UNITED WAMBO OPEN CUT COAL MINE PROJECT

RESPONSE TO REQUEST
FOR FURTHER INFORMATION

Response to Request for Further Information

Prepared by
Umwelt (Australia) Pty Limited
on behalf of
United Collieries Pty Limited

FIGURE 2.1

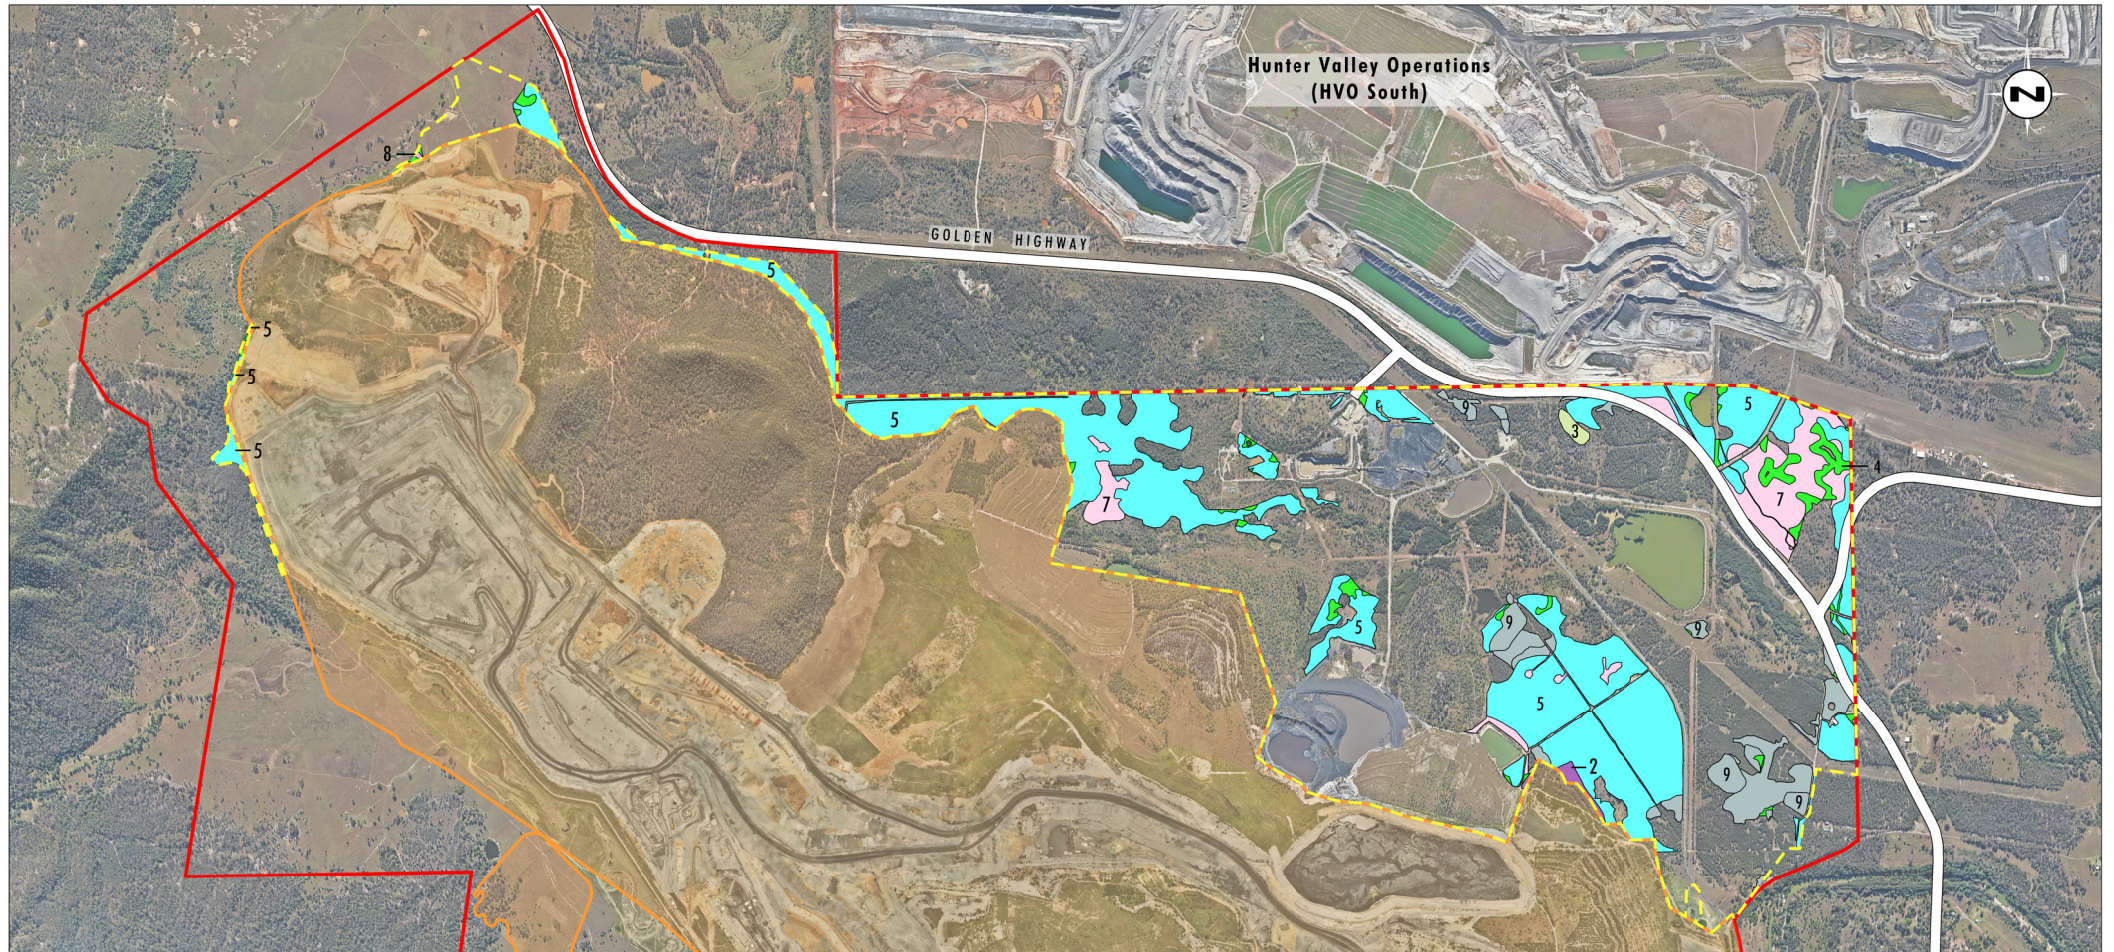
As a result of the revised mapping of CHVEFW CEEC, a further 12.1 hectares of HU906 – Bull Oak Grassy Woodland of the Central Hunter Valley – Moderate to Good condition is considered to conform. Adequate densities of characteristic eucalypt species, likely to be *Eucalyptus crebra*, were identified in several areas (refer to **Figure 2.1**). In addition to this, a further 0.2 hectares of derived native grasslands is considered to conform to the CHVEFW CEEC given that it occurs in a gap between two patches which are less than 30 metres apart or at an indent along the edge of the CHVEFW CEEC. This amendment results in a total impact on the CHVEFW CEEC of 201.8 hectares compared to 189.5 hectares quoted in the RTS.

The change to CHVEFW CEEC mapping results in an additional 710 credits required specifically for the CEEC over the life of the Project, but no change in credit requirements overall. Table 6.2 of the FBA has been updated as per **Table 2.3** below (red text denotes changes). Furthermore, credit allocations outlined in **Table 2.2** have been updated to reflect these mapping amendments.

FIGURE 2.2
Proposed Premises Plan

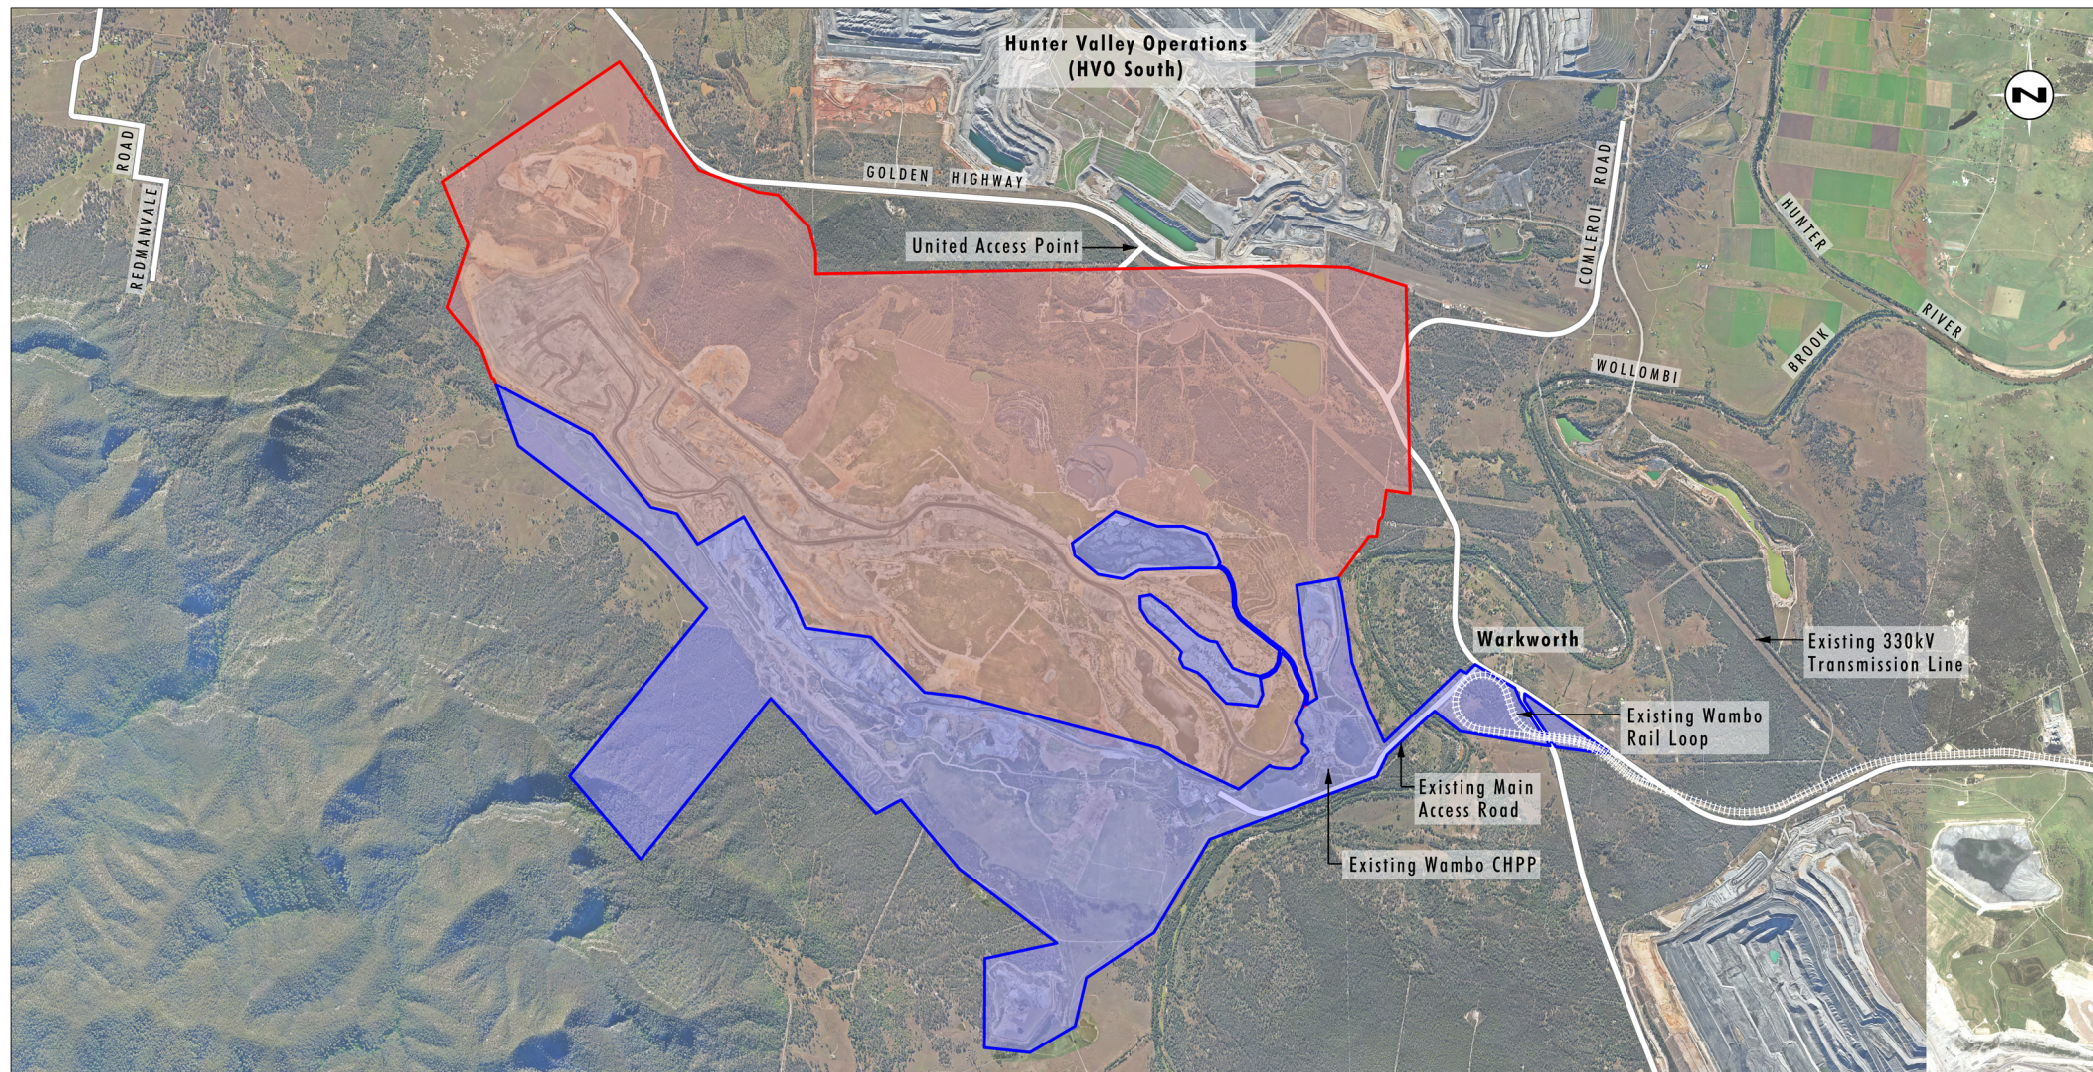
Premise plan

The proposed premises plan for the initial stage of the Project is shown in **Figure 2.2**. It is noted that the premises plan will change from time to time based on the ongoing progression of the United and Wambo mines.

Graph 1 United final void water and salinity balance

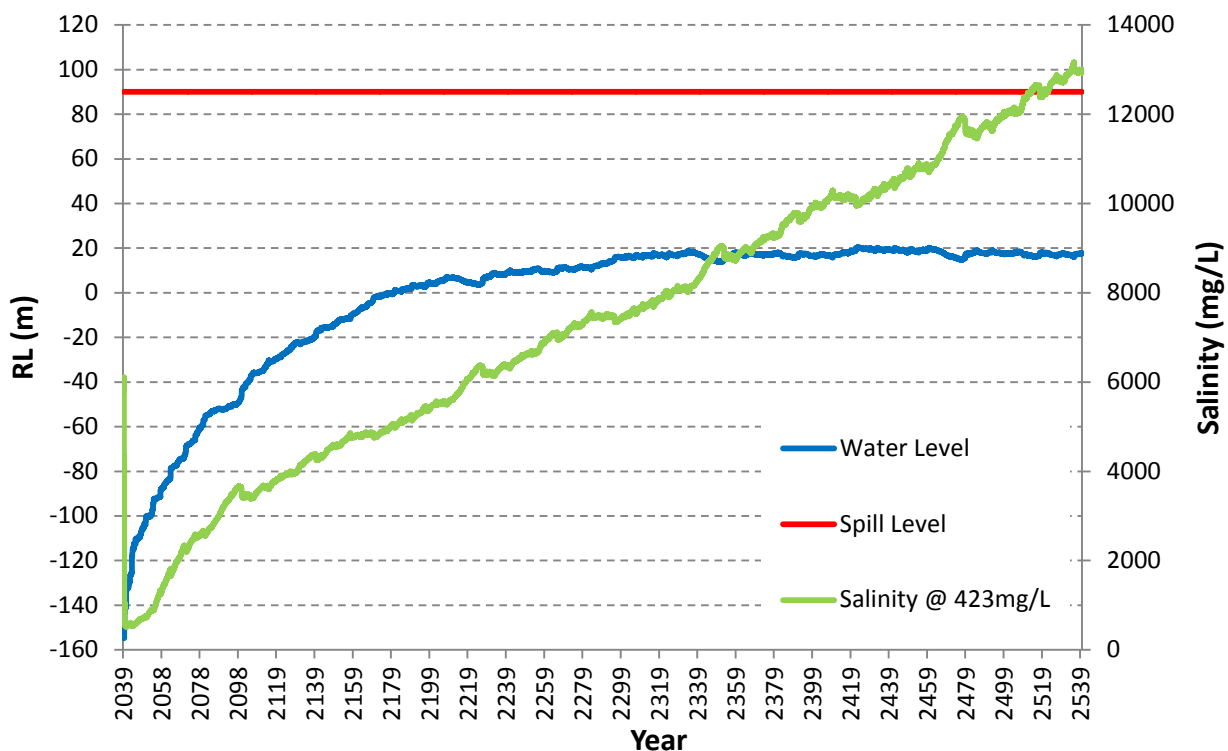
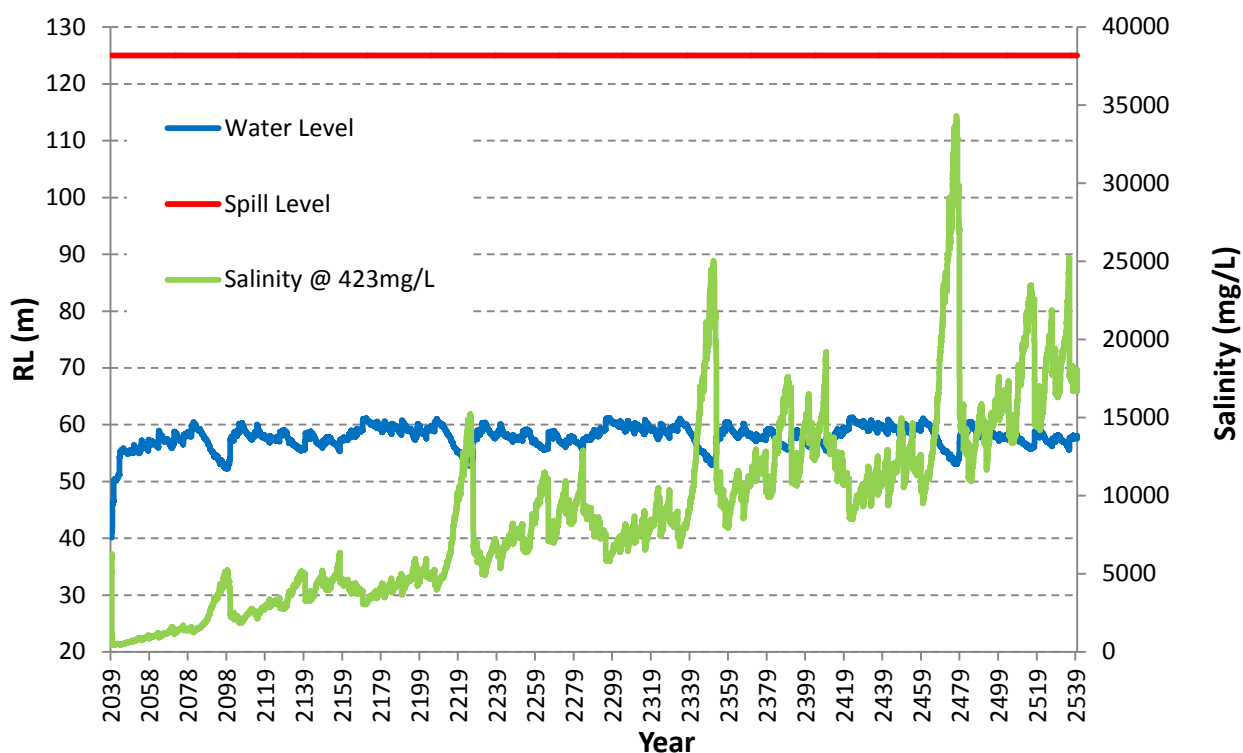
Questions have been raised regarding the predicted salinity of the final voids for the Project. In particular, questions regarding the Wambo void which was predicted in the EIS to reach hyper-salinity relatively quickly. In response to these questions further work has been undertaken on final void salinity with the results discussed below.

Based on this revised modelling, the final void water levels and quality have been re-predicted. This updated modelling has identified that the level of salinity in both final voids after 500 years will be less than that predicted in the EIS, substantially so for the Wambo void, being:

- final void salinity in the United void of approximately 13,000mg/L after 500 years
- final void salinity in the Wambo void of approximately 17,000mg/L after 500 years.

The EIS predicted that the United and Wambo void salinity would be approximately 35,000mg/L and 300,000mg/L, respectively. By way of comparison, the salinity of seawater is approximately 35,000mg/L. As can be seen in the revised results, the predicted salinity in the Wambo void has significantly reduced, while it has approximately halved in the United void. As discussed above, the original HEC final void modelling has been identified as providing unrealistically high salinity levels after 500 years and the revised modelling, which has been subject to technical peer review, provides a more accurate prediction of void salinity.

Figure 3 Changes due to Final Landform Refinement: Level-Volume-Area United

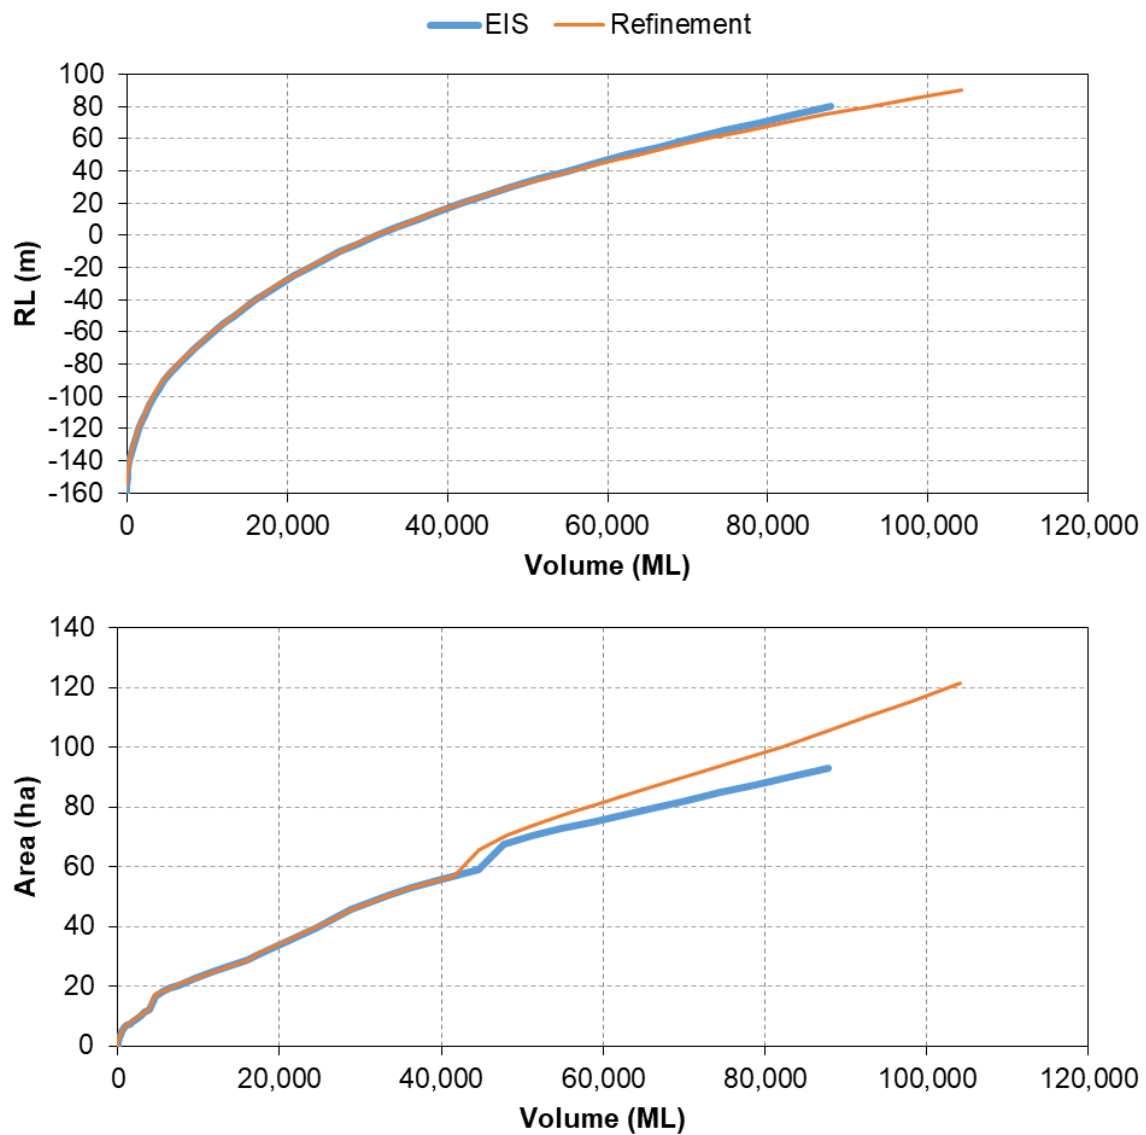
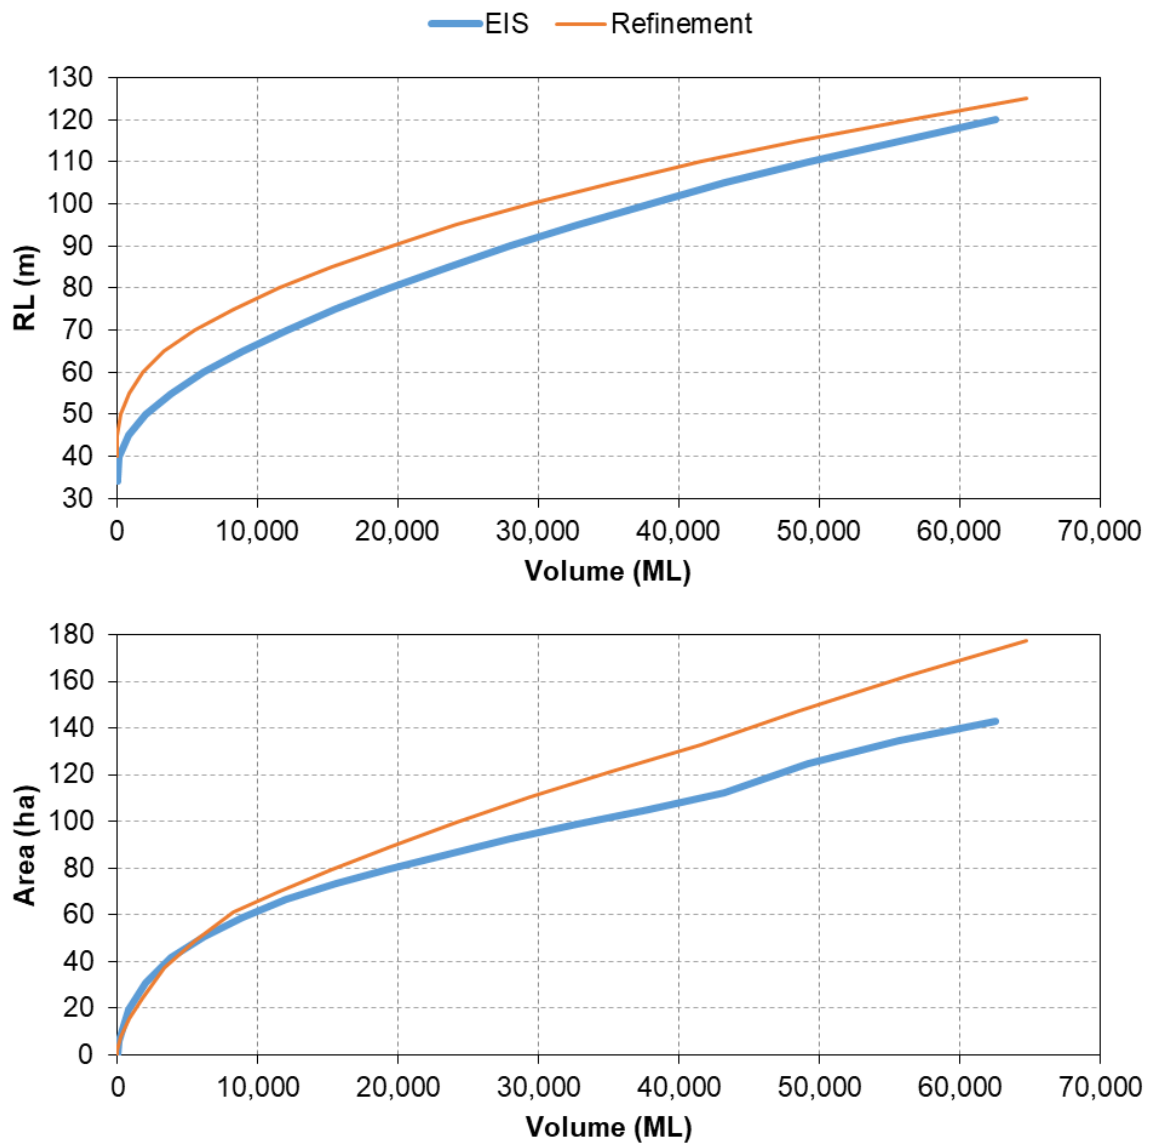
A third model refinement was included as a result of a change to the final landform plan. The change to the final landform resulted in subsequent changes to void storage characteristics (i.e. level-volume-area relationships) and catchment areas. Changes to storage characteristics are summarised in Figure 3 and Figure 4 for the United and Wambo voids respectively.

Figure 5 EIS Refinements Final Void Results: United

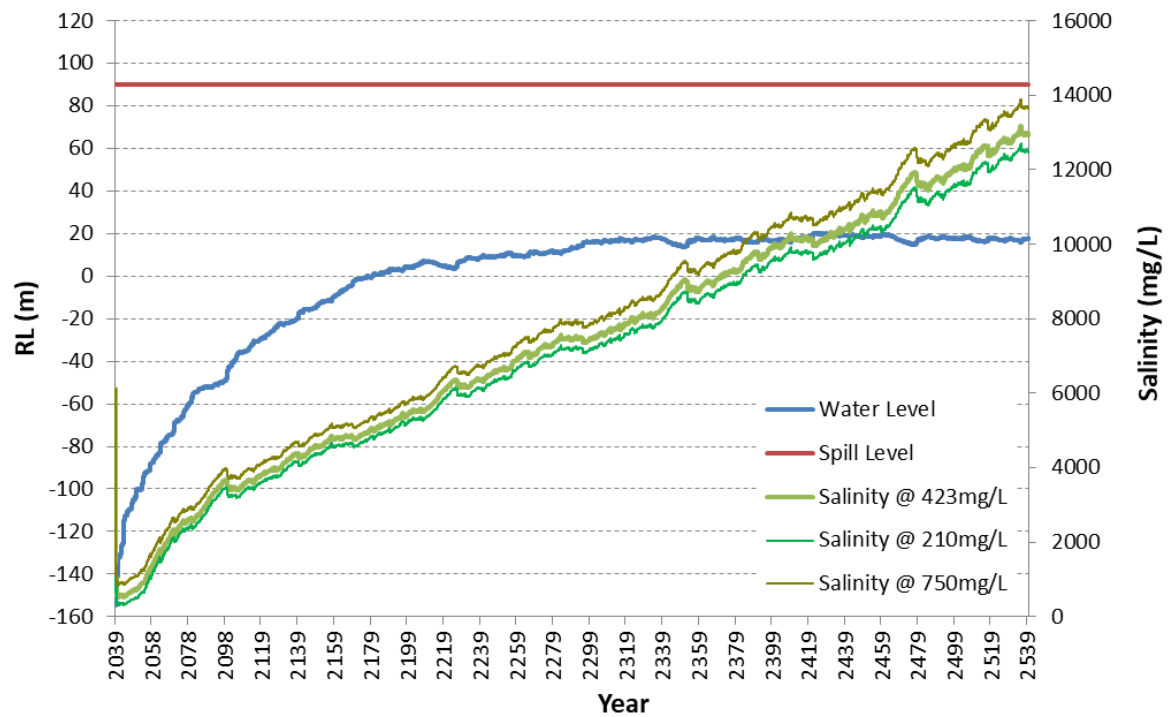
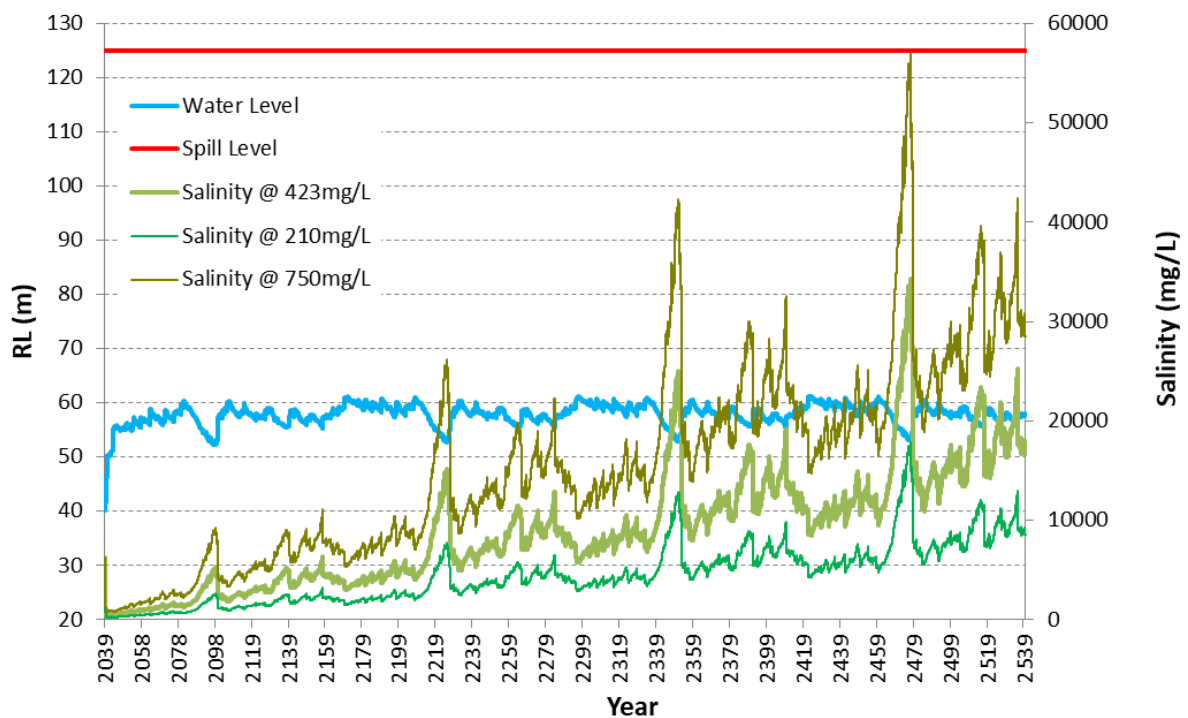
Simulated water level and salinity for both the United and Wambo final voids with these refinements included are shown in Figure 5 and Figure 6. Note this has that resulted in a lowering of the predicted salinity at the end of the 500 year modelling period to 13,000 mg/L and 17,000 mg/L for the United and Wambo final voids respectively. However these voids

will still ultimately tend towards hyper-salinity (well beyond the modelled 500 year simulation).
